N7002A-01

# Modification Recommended Service Note

N7002A InfiniiMax III+ Series 16 GHz Probe Amplifier  
Serial Numbers: ALL

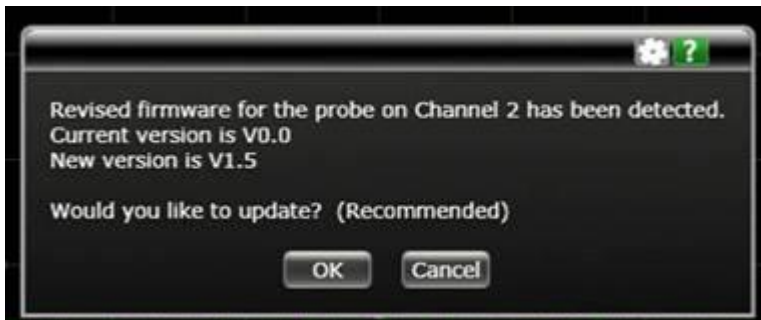
1. Ask the customer if he/she has seen the following message when plugging his/her probe onto an oscilloscope:

2. Regardless of the customer's answer to the question, plug the customer's probe onto a Service Center scope with software version 06.20.00701 or later.
3. If the Customer said No in step 1 or was unsure: tell the customer that Keysight recommends downloading latest scope software version—Version 06.20.00701 or later. Continue with standard procedure.
4. If the Customer said Yes, the probe appears to function normally on the scope, and it passes calibration, the probe has been fixed. Send the original probe back to the customer, and tell the customer that Keysight recommends an upgrade to oscilloscope software—Version 06.20.00701 or later to prevent this issue from re-occurring to their probe.
